**CITY OF CHARLOTTESVILLE  
BOARD OF ARCHITECTURAL REVIEW  
STAFF REPORT  
November 20, 2018**

**Certificate of Appropriateness Application**

BAR 18-11-05

**Front Door Replacement**

CURRENT

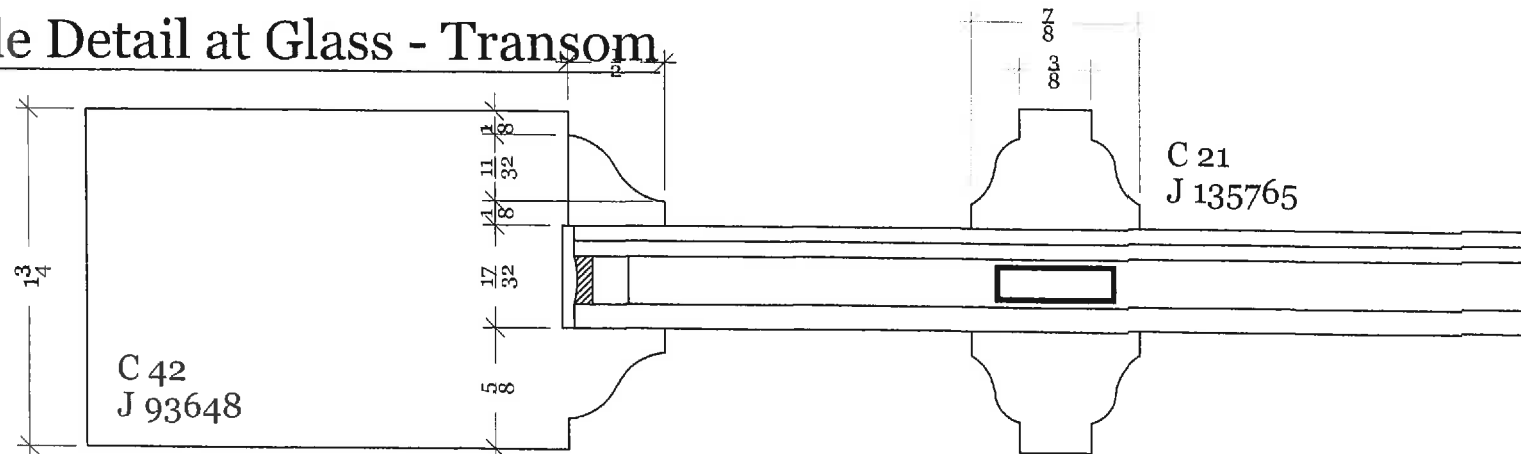
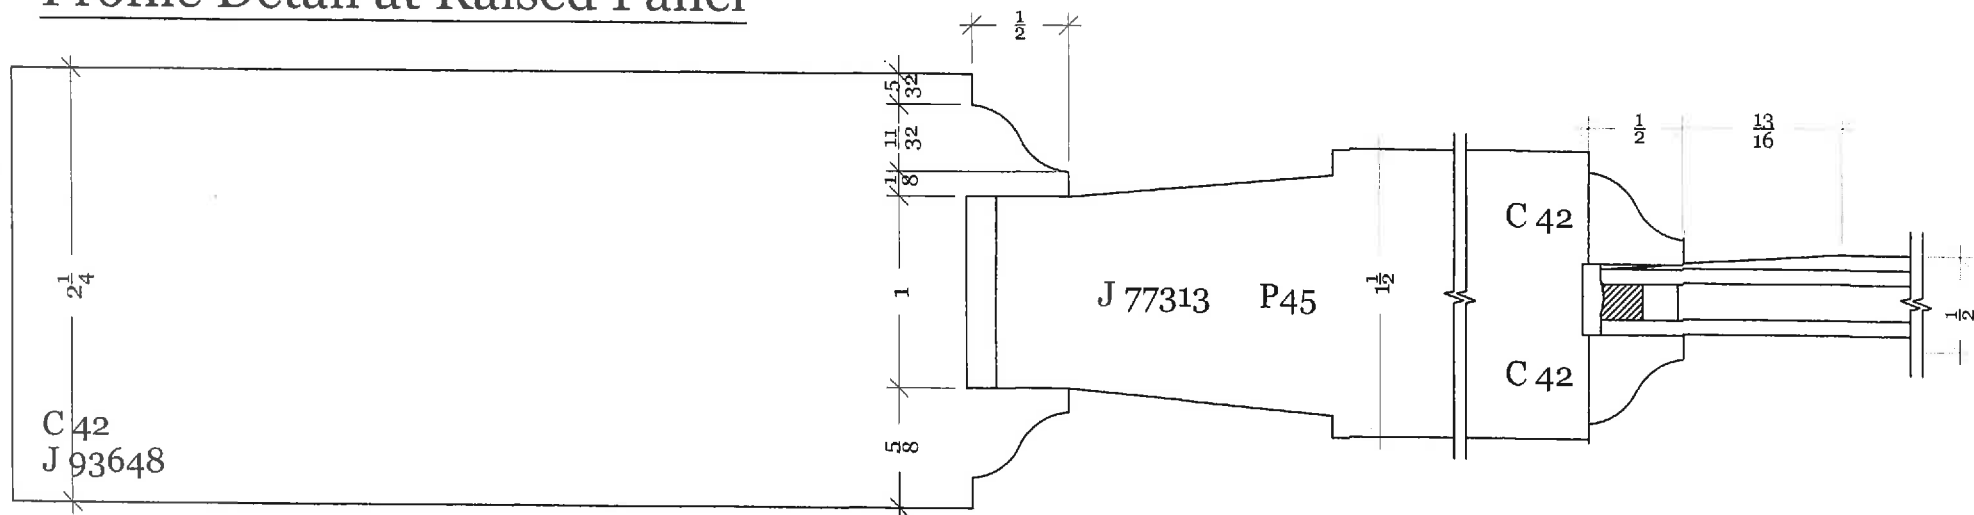
Staff acknowledges that replacing these doors is almost entirely a function of improving security; that the existing doors are slightly warped and the lower panels are too thin to be incorporated into the new. (Staff discussed this with the applicant and while it did not prove practicable, we commend them for discussing this it with the door manufacturer.)

While the new doors will be very similar to the existing, there are details that will not be replicated: the applied medallions on the lower panels; the beaded profile on the stop moulding for the oval glass panes and door panels; and the beveled rim on the oval glass. (In the city's 1982 historic survey, the paired doors are described as each having a *large oval light over a decorated panel*.)

If the replacement is approved, Staff suggests that the applicant consider either storing the doors, should future restoration be pursued or, at the very least, retaining the oval glass and decorative panels to be displayed or stored.
